SERVICE INFORMATION LETTER NO. 0154

1. SUBJECT: Starter Circuit Wiring Modification
2. MODEL: F-28F, 280F, and 280FX
3. EFFECTIVITY: All serial numbers
4. BACKGROUND:

Figure 1.

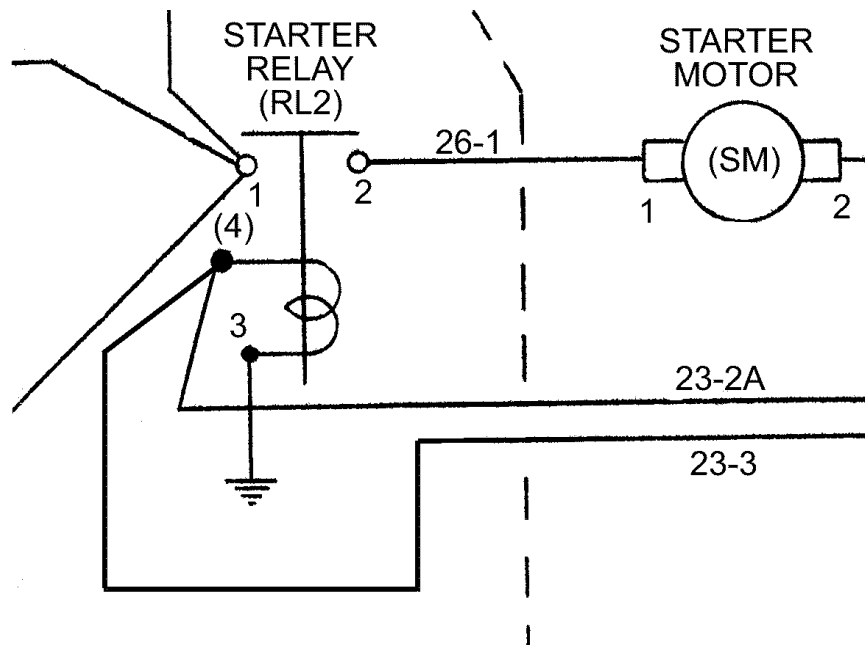
- a. Remove wire 23-3 from terminal 2 of the start relay (RL2). Remove the terminal from the end of the wire and install a new terminal (P/N BB-837-10 or equivalent). Install wire 23-3 on the start relay coil terminal (terminal 4) along with wire 23-2A (Refer to Figure 1).
- b. Aircraft equipped with a 24 volt electrical system: Remove the starter switch from the pilot’s collective stick. Disconnect the pushbutton switch from the wiring and install a new switch (P/N 30-1UL). Install the starter switch into the pilot’s collective stick.
- c. Aircraft equipped with a 24 volt electrical system: Determine the rating of the “START” or “IGNITION” switch/circuit breaker in the switch panel. If the
